01 Types NOT intended as complying development (Scale and type of development too large for CDC) (Typologies also poor exemplars)

02 Inconsistent definitions and Development Standards

03 Inconsistent references to 'public' roads, 'frontage' and 'lots'

04 Development now able to be approved by CDC with no independent, accountable consent process

Figure 2 Multi-Dwelling Housing and Master Planned Communities (MDDG Figure 3-10, p119)

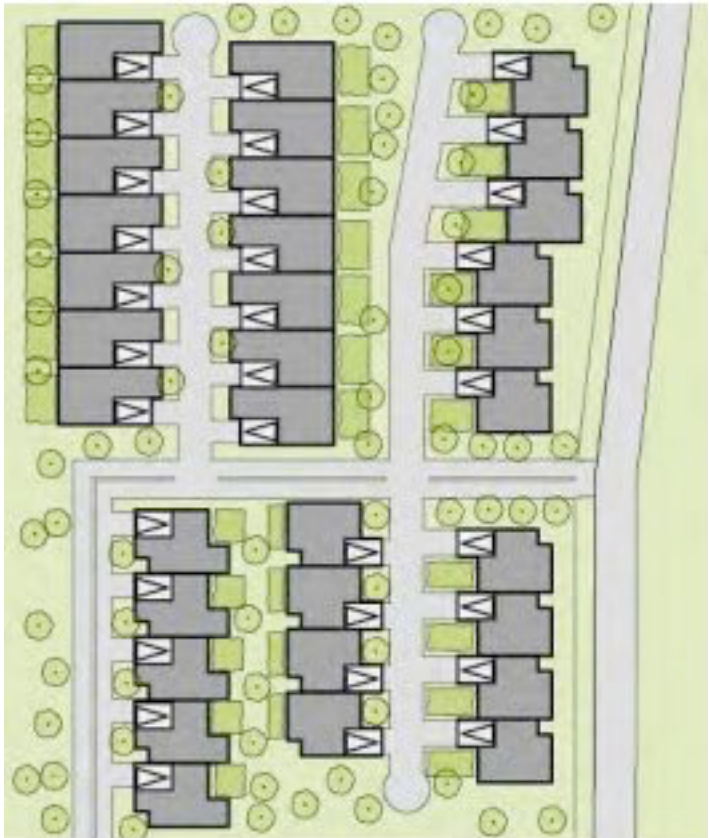
NOTE: SILEP definition inconsistent with Codes SEPP

NOTE: Different term to Codes SEPP

Figure 3 LARGE AMALGAMATED SUBDIVISION (MDDG p119) Could be a combination of one or all of the Medium Density Housing types (depending on local land-use zone)

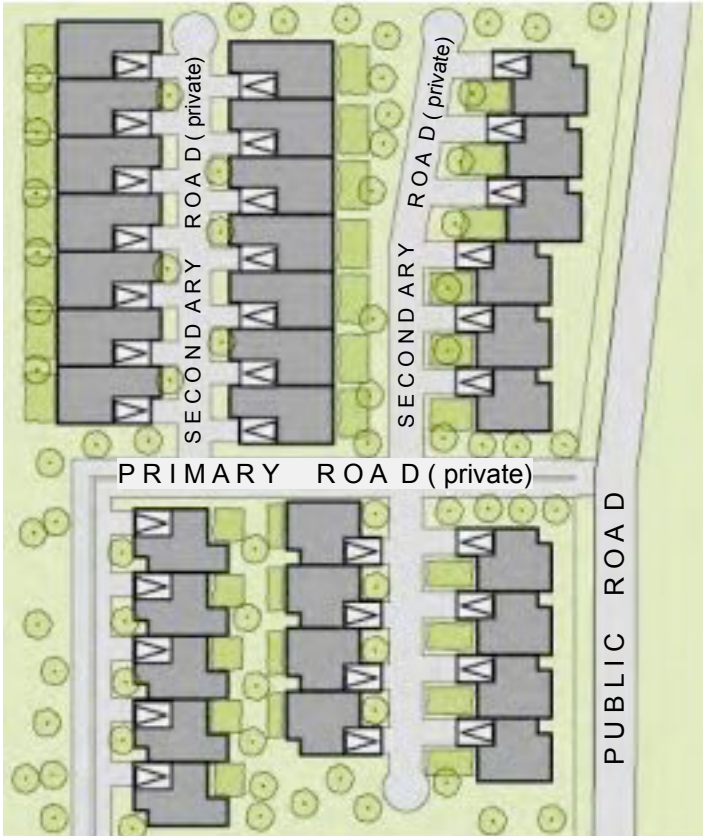
Completed development complies with (d), (e), and (f) of the Specified Development

Intent for large scale complying development reinforced at MDDG: (typical requirements for all CDC medium density types)

Objective 3.3F-3 Design Criteria 27, 29, refers development of "more than 20 dwellings"

Objective 3.3F-4 Design Criteria 32 implies car parking for more than 10 dwellings.
